Kilchis Porter Restoration Review

Final Report, Rev. 2

The Nature Conservancy

The Nature Conservancy (TNC) contracted with Northwest Hydraulic Consultants (NHC) to perform a technical hydraulic review of one completed (Dooher) and one planned (Porter Tract) restoration project on the TNC-owned Kilchis Estuary Preserve. The scope of work was developed in concert with the Tillamook County Creamery Association (TCCA) and Tillamook Bay Flood Improvement District and consisted of twelve items to be addressed. TNC provided all relevant reports, data, and hydraulic models to be reviewed. In the report body the twelve items are addressed individually even though there is some overlap and common elements between them. This executive summary describes the key findings of the review, which in some cases are synthesized from the analysis of several scope items.

Figure 3: Observed Stasek near Culvert (Gray) and Hathaway (Pink) gage data and estimated true Stasek low tide hydrograph (Blue)

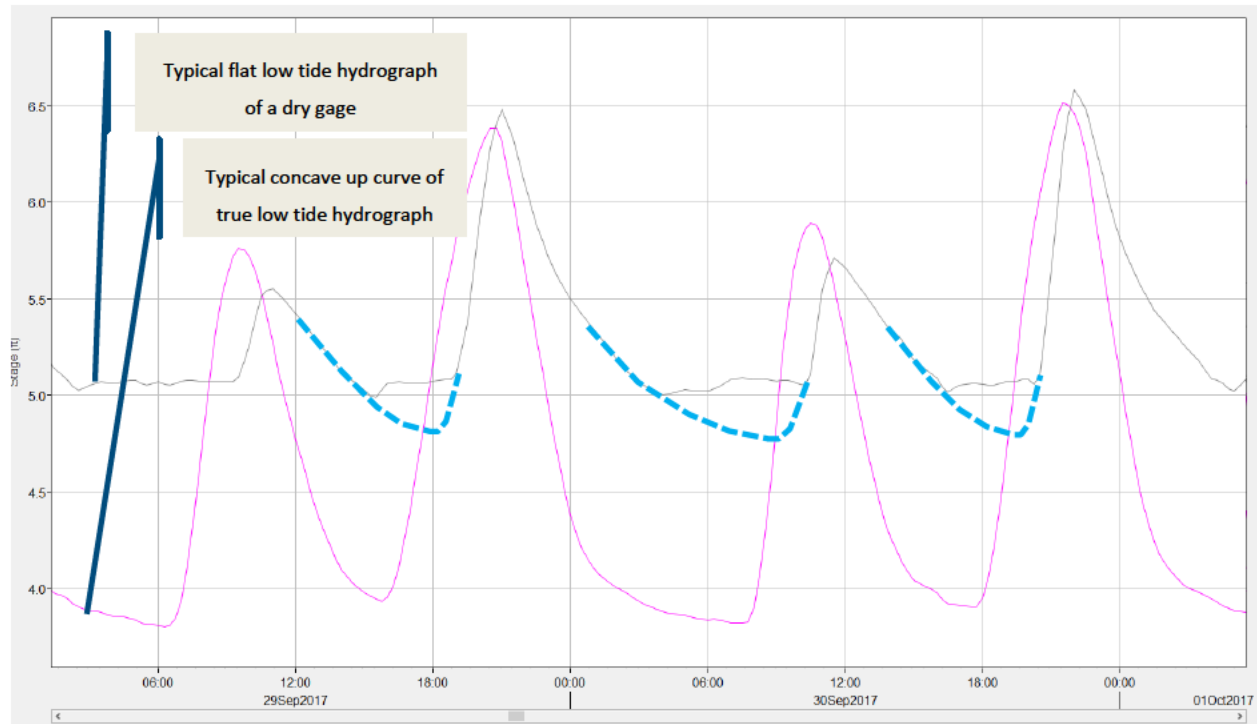
- Hathaway Slough. This gage was consistently 0.9 feet higher at high tide compared to all the other gages and the Garibaldi gage. The same pattern existed at low tide. This suggests an error in the datum conversion elevation for this gage. We applied a -0.9-foot correction to the time series to match the other gages at summer high tides.

Based on logged depth readings near zero and characteristic flat hydrograph shape, we determined that all post-2016 gages except Hathaway and the Kilchis River downstream of Highway 101 go dry on low tides. Since we expect the Hathaway gage to have the lowest low tide readings of all the gages, and this gage does not go dry, this gage serves as a lower limit on low tide levels at the other gages. None of the pre-2016 gages (Hathaway, Squeedunk, Stasek) appeared to go dry on low tide, although the Stasek gage was very close. We did not remove the 'dry' gage data but mention it as something to keep in mind when looking at figures in this report.

We used the post-project Stasek near Culvert gage as a key dataset for evaluating project impacts. This gage goes dry at an elevation of 5.0-5.1 feet. Using a comparison with the Hathaway Slough gage and projecting out approximate expected water levels had the gage not gone dry, we estimate that the true minimum low tide at this gage is about 4.8 feet. We checked this across multiple summer periods and have high confidence in this conclusion, within a tenth of a foot or so. We consider this 0.2 to 0.3 feet of 'missing data' to be minor. The following discussion uses statistics from this gage with minimum elevations of 5.0 feet, but we have called out our estimate that the true low tides should be about 4.8 feet on the relevant figures and narrative. Figure 3 shows a typical example of how the hydrograph from a dry gage looks compared to one that remains wetted and how we estimated the true minimum low tide elevation for the Stasek Slough gage.

Figure 4: Comparison of Stasek Slough water levels pre- (left) and post- (right) Dooher project under similar river flow and high tide conditions. Note that high tides remain closely matched with Garibaldi high tides but low tides increase by around two feet.

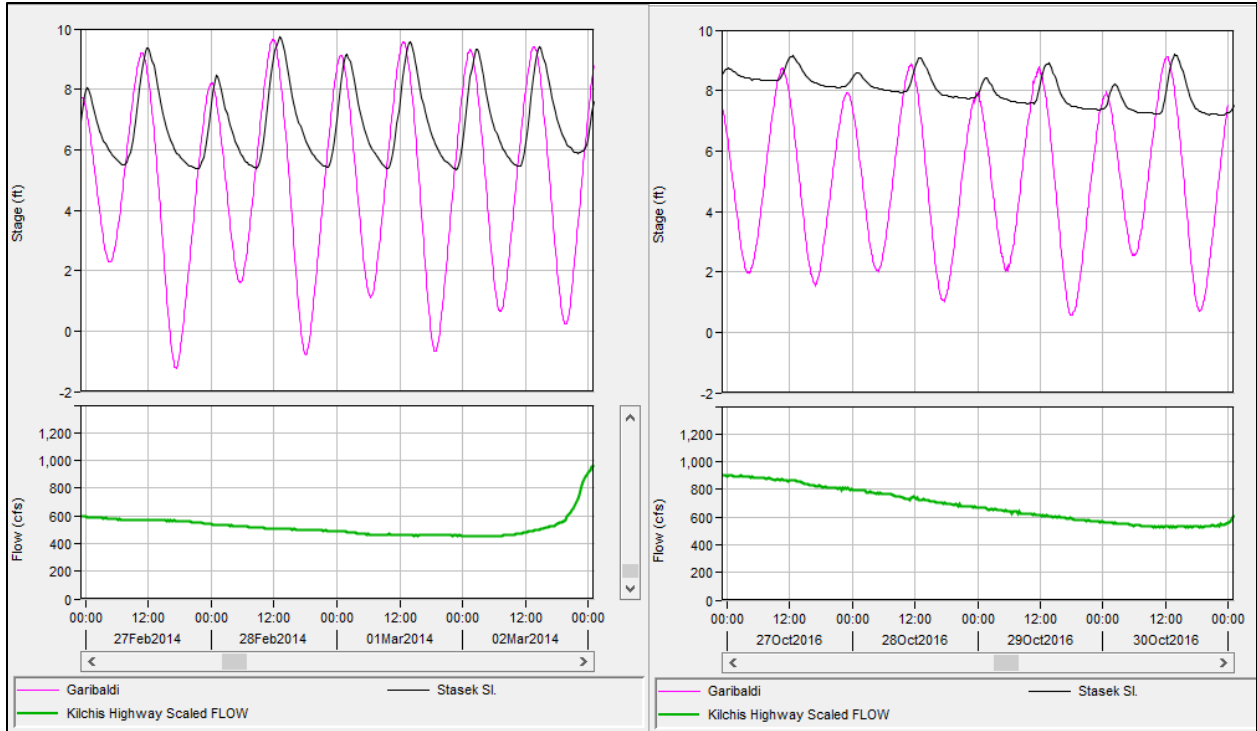
Water level changes in Stasek Slough due to the Dooher project are significant and vary by season. We present the differences in a variety of different figures in this section, but perhaps the simplest way to visualize the difference for wet season conditions is to plot Stasek Slough stage from a pre- and post-project time when river flows and high tides were very similar (Figure 4). This figure shows that while high tides in Stasek Slough closely match those in Garibaldi, minimum low tide levels were increased by around two feet, reducing the tidal amplitude from over three feet to one foot.

Figure 6: Observed semi-monthly averaged maximum (top), mean (middle), and minimum (bottom) of daily water levels for Hathaway Slough (blue) and Stasek Slough (pink). Dashed lines for 2014 Stasek Slough data indicate upper and lower uncertainty bounds.

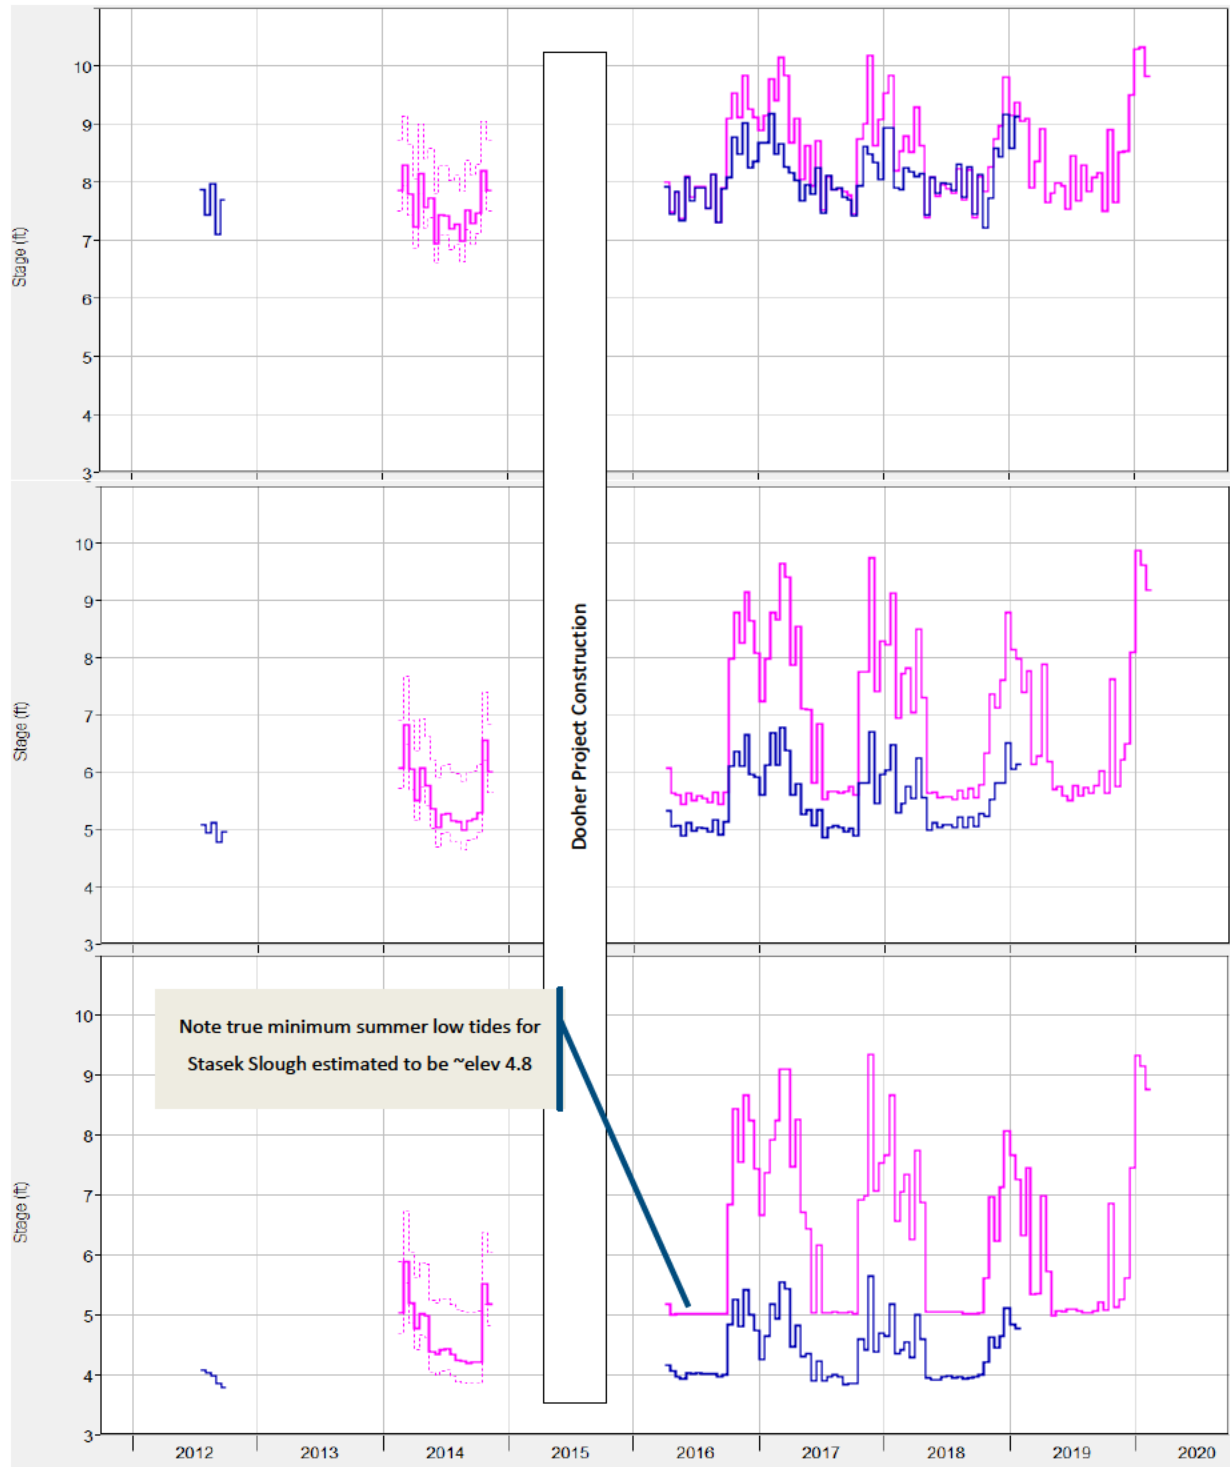
We applied some averaging to the timeseries data to better evaluate seasonal changes in water level due to the Dooher project. Figure 6 shows averaged Hathaway and Stasek Slough water levels. The stage was developed by first creating daily maximum, minimum, and average water level records (the daily maximum and minimum are a close surrogate for higher high and lower low tides). We then averaged these data over a semi-monthly (i.e., approximately bi-weekly) period, which provides better estimates of longer duration water level trends and makes for clearer figures.

Referring to Figure 6, summer maximum average levels have increased from 7.3 to 7.9 feet. Minimum levels have increased from 4.2 to 4.8 feet, and mean levels increased from 5.1 to 5.6 feet. Prior to the Dooher project, maximum water levels were a few tenths lower than Hathaway Slough, average water levels similar, and minimum water levels about 0.2 feet higher. The smaller amplitude (difference between highs and lows) is attributed to the muting effect of the connector culvert on flow exchange between Hathaway and Stasek Slough prior to Dooher project construction. Post-construction, the connector culvert still limits flow out to Hathaway, but Stasek Slough sees much more inflow from the Kilchis River connection. This creates the increases in water levels over the summer months.

Hathaway Slough water levels are shown in purple in Figure 6. There is minimal pre-project data, covering a few late summer months in 2012. Comparing minimum, maximum, and average curves with the post-project data, no significant change has occurred for summer months. For instance, the averaged low tides have remained around an elevation of five feet in all years shown.

Figure 10: Stasek and Hathaway Slough observed water surface elevation (top), difference in stage (middle), and Kilchis River flows for reference (bottom).

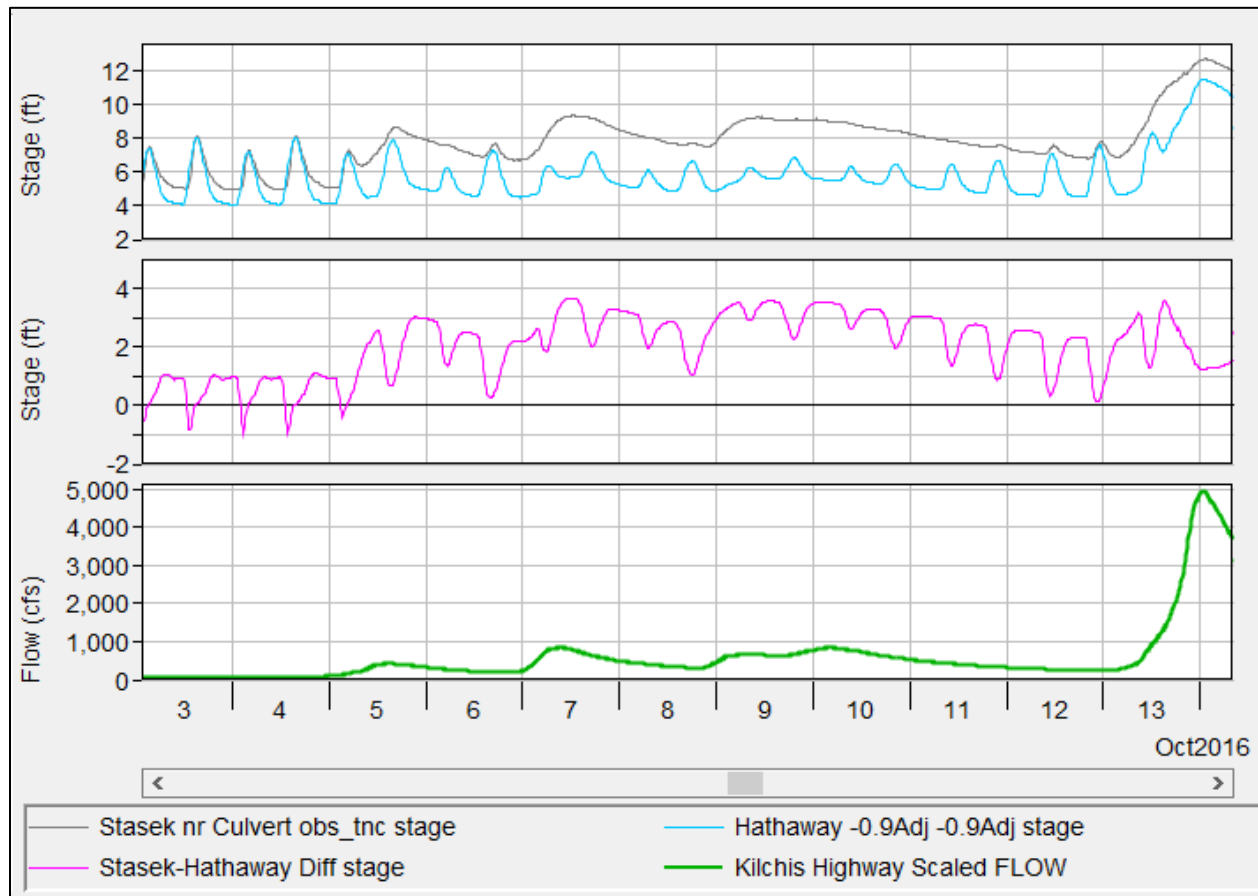
However, we believe it likely that there have been some increases in winter water levels due to the Dooher project, driven by the significant increases observed in Stasek Slough. Figure 10 plots Stasek and Hathaway Slough observed water levels, as well as the difference between them, and estimated Kilchis River flows. At the beginning of the period with very low river flows, the differences vary between +1 and -1 feet, indicating bi-directional flow in the connector culvert between the two sloughs. Once flows begin to rise, the difference increases to two to three feet on average and is always positive, indicating continuous one-way flow from Stasek Slough to Hathaway Slough through the connector culvert. Once flows exceed about 3,000 cfs, Stasek Slough water levels exceed 11 feet (Figure 5). At this elevation, water begins to spill from Stasek Slough to Hathaway Slough over the floodplain on TNC property and also over a low point just upstream of Highway 101 (mentioned as an observation by Leo Kuntz in his 'staircase' memorandum (Kuntz, 2017)). This evidence indicates that flows into Hathaway Slough have been increased by the Dooher project during winter months. Increasing flows in tidal sloughs almost always result in reduced (higher) low tides. In contrast, it typically takes far larger flow increases to affect high tide levels, so we believe it unlikely that the probability of overtopping of the west side Hathaway Slough dikes into the Vaughn Creek unit has been increased. We do not know the magnitude of the increase from available model data, observed data, or reports. We therefore do not know if they are significant or not, although Leo Kuntz's observations in his letter imply that Hathaway Slough was not affected nearly to the degree that Stasek Slough was by the project.

Figure 13: Difference in stage between existing and proposed Porter project conditions versus Kilchis River Flow

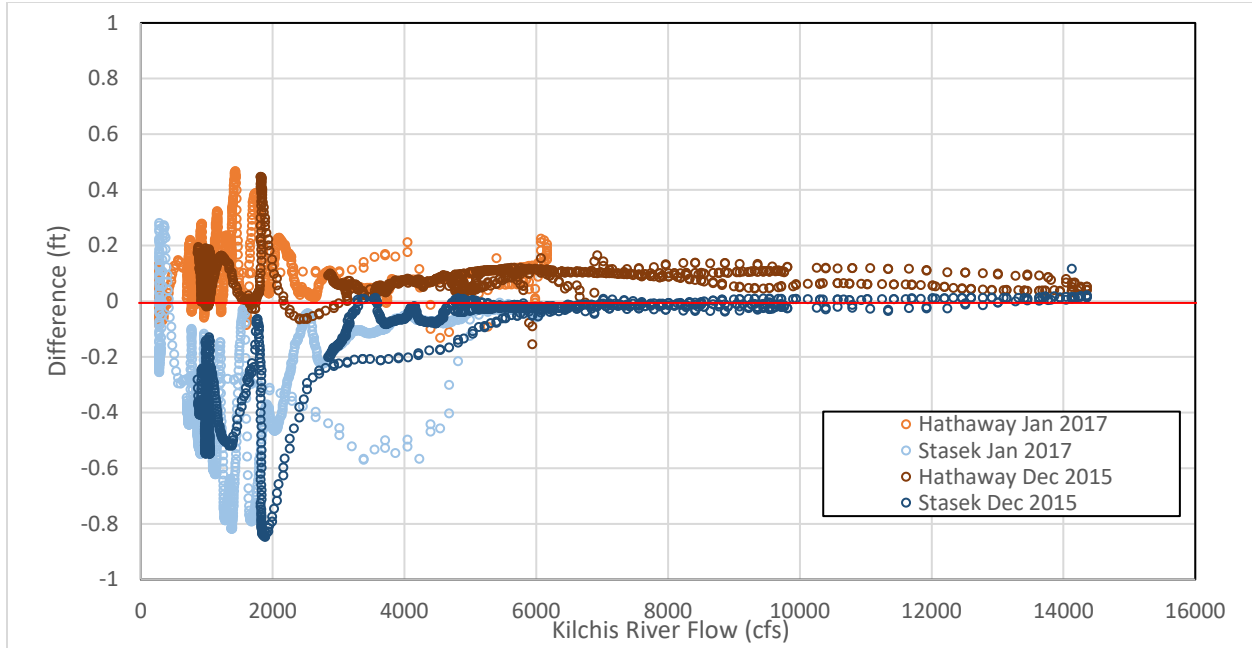
Figure 13 presents the stage differences for both simulations as stage difference versus flow plots. This figure shows that, below about 500 cfs, differences in water levels between existing and post-project conditions are less than 0.2 feet and oscillate about zero (Figure 12, first day and a half). The largest differences occur between around 1,000 cfs and 2,500 cfs, with Stasek Slough water levels up to 0.8 feet lower than under existing conditions and Hathaway Slough water levels up to 0.5 feet higher. As flows increase further, the differences diminish. Stasek Slough stage differences tend towards zero, but Hathaway Slough shows a persistent small rise of about 0.1 feet through the flood peak. This change is attributed to greater connectivity between the sloughs due to the culvert removal, allowing more effective drainage of Stasek Slough but routing this water into Hathaway Slough. The Porter project is essentially reducing the head difference between the two sloughs. The effects of these changes in the sloughs propagate upstream of Highway 101; Figure 14 illustrates a representative time period with water surface differences plotted.

Based on the modeling, we expect very little change in hydrology in the area during summer low flow months when flows are below 500 cfs. During the winter, Hathaway Slough will see water level increases up to 0.5 feet at times, with average increases of perhaps 0.2 feet; this could affect drainage from the Vaughn Creek and Hathaway units. The increases will mostly occur on the low tide. Water levels in the Stasek and Neilson units will go down, up to 0.8 feet at certain flows and averaging perhaps 0.4 feet. The largest decrease in water level occurs on the low tide for these units. The changes on all units are at their maximum when river flows are between 1,000 and 2,000 cfs. Water levels on the Kilchis RB unit

Figure 15: Change in water surface elevation due to Porter project on December 9, 2015, 11:00 (flood peak) from (NHC, 2019)

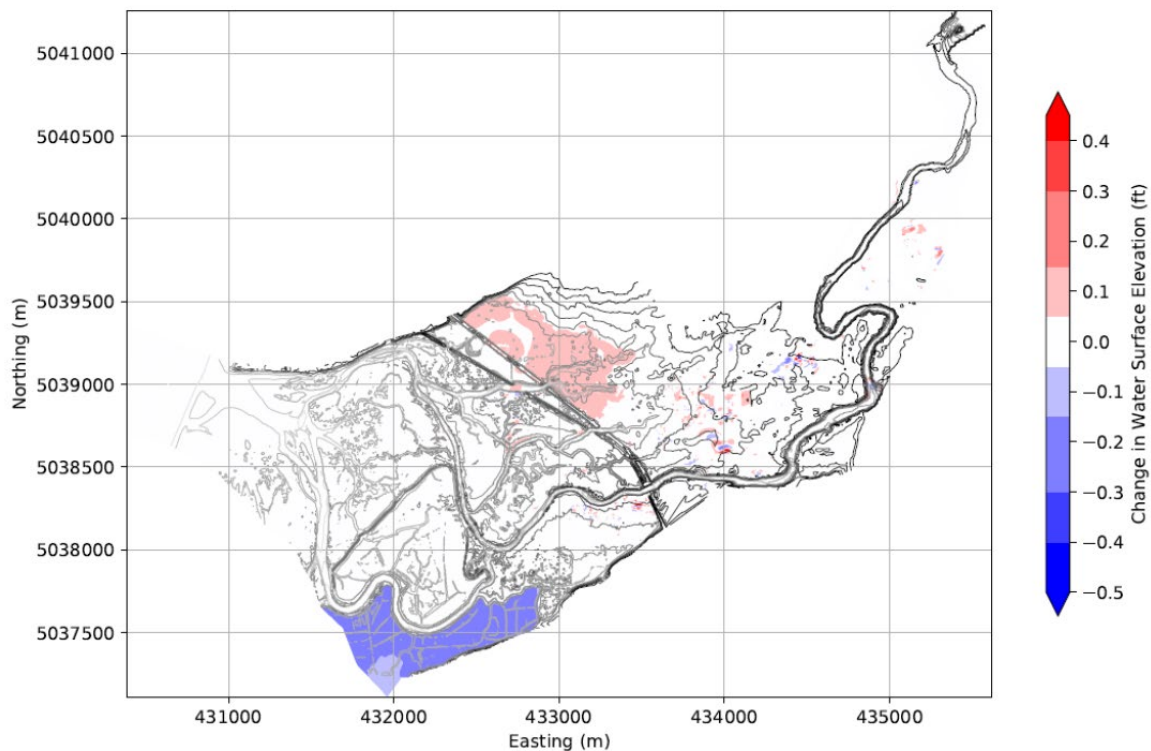
Changes in flood water levels due to the Porter project are less than the changes predicted under normal flow conditions. Project induced increases in water surface elevations tend towards zero as flows exceed 6,000 cfs on the Kilchis River for both Stasek and Hathaway Sloughs, although the latter sees a small persistent increase of about 0.1 feet through all but the very peak of the floods (Figure 11, Figure 12, Figure 13). This increase will be seen in the Vaughn Creek, Hathaway, and Stasek units for floods large enough to overtop the banks and dikes (Figure 15).

Figure 17: Left - LiDAR image showing apparent gap in levee, Right – model mesh showing same gap

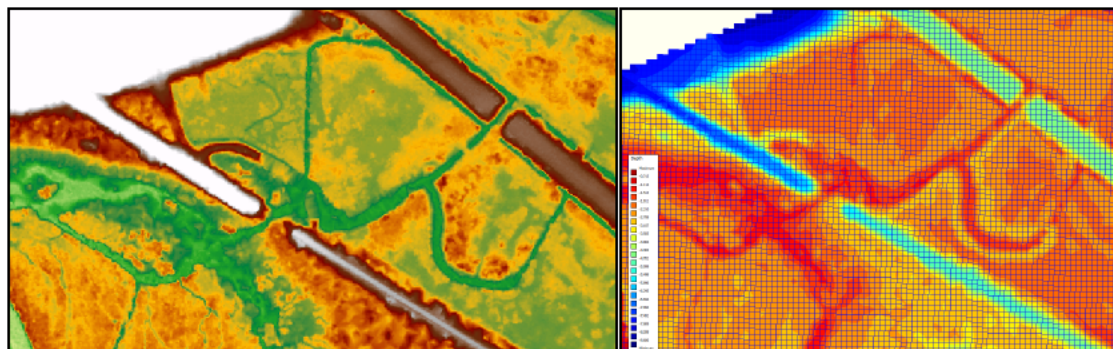
For the Porter model(s), the representation was generally good except for three issues in the Vaughn Creek unit. To the north of the Porter Tract (off TNC lands), there is a dike built across an unnamed slough that conveys at least part of the flow of Vaughn Creek (Figure 16). The dike is not large, and in fact neither LiDAR dataset examined captured it, and since no ground survey was conducted in this area it was not represented in the model (Figure 17). From a hydrologic standpoint, it makes logical sense to build a dike here; otherwise, high tides would routinely flood under Highway 101 and inundate the low-lying areas to the north. Leo Kuntz confirmed the existence of this dike, noting there were two tidegates in it, and he had repaired it several times over the years.

Due to the small opening under the railroad tracks and the 15-foot grid resolution, the model does not capture the true low point of the opening. The LiDAR elevations are around five feet, and the true bottom of channel is probably at least three feet lower, but the model mesh resolution imposes an artificial barrier with an elevation around nine feet in the opening. This is probably two to three feet lower than the true dike elevation at a minimum but does keep out most normal tides from the area to the north.

Figure 18: Approximate tributary watersheds

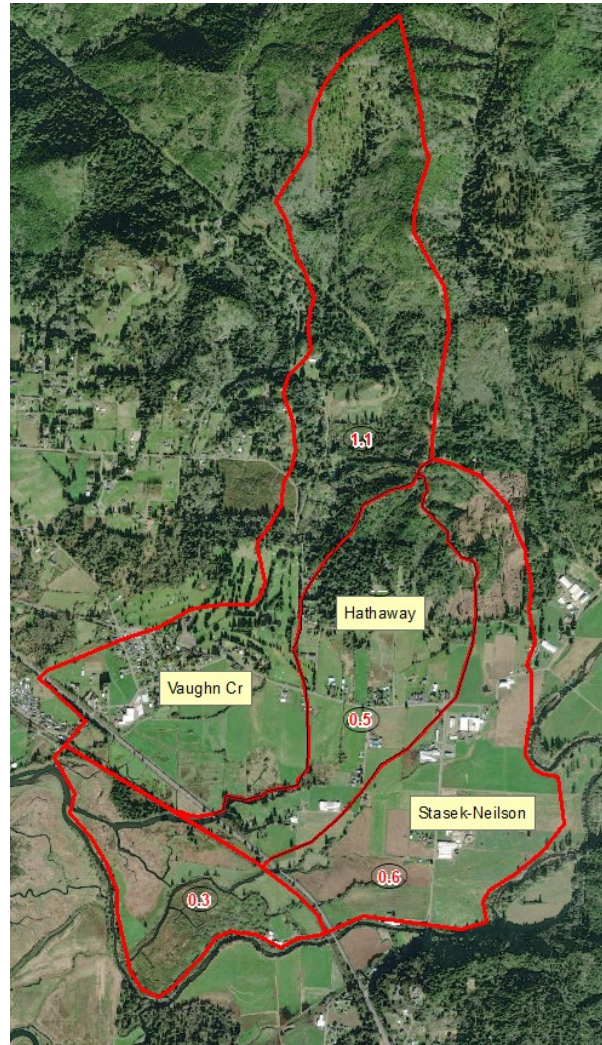
The Doohar model report (PWA ESA, 2013) notes a local tributary inflow was included for Hathaway Slough. The report has a flood frequency table that includes 50 cfs as the Hathaway Slough inflow for a 2-year flood event. However, the rest of the report, including sections on calibration, low-flow, and flood simulations, does not document how flows were estimated or used for Hathaway Slough in the model. It is unclear what was included in the assumed tributary area for the Hathaway Slough model input. We applied the USGS StreamStats model (<https://streamstats.usgs.gov/ss/>) for the total watershed above the railroad including the Vaughn Creek, Hathaway, and Stasek sub basins (Figure 18). The 2.2-square mile watershed generates a 2-year flood flow estimate of 146 cfs; the same source reports for a 17-year gage record on adjacent Patterson Creek (1.9 square miles) the 2-year flood was estimated at 107 cfs. This suggests that total local inflows for the Doohar model may be underestimated. No tributary inflows appear to have been used in any of the Porter Tract models.

Estimation of local tributary inflows is a key component for a robust drainage analysis. We recommend that flow estimates be developed or measured in the field for the sub-watersheds shown in Figure 18 and applied at appropriate model locations. Summary results from the StreamStats analysis are shown in Table 5. One caution is that subsided areas with significant lengths of dike along tidal channels may have much more inflow from seepage through and under the dike than from hillside tributaries. Vaughn Creek is the hydrologic unit in this area where this might be an issue.
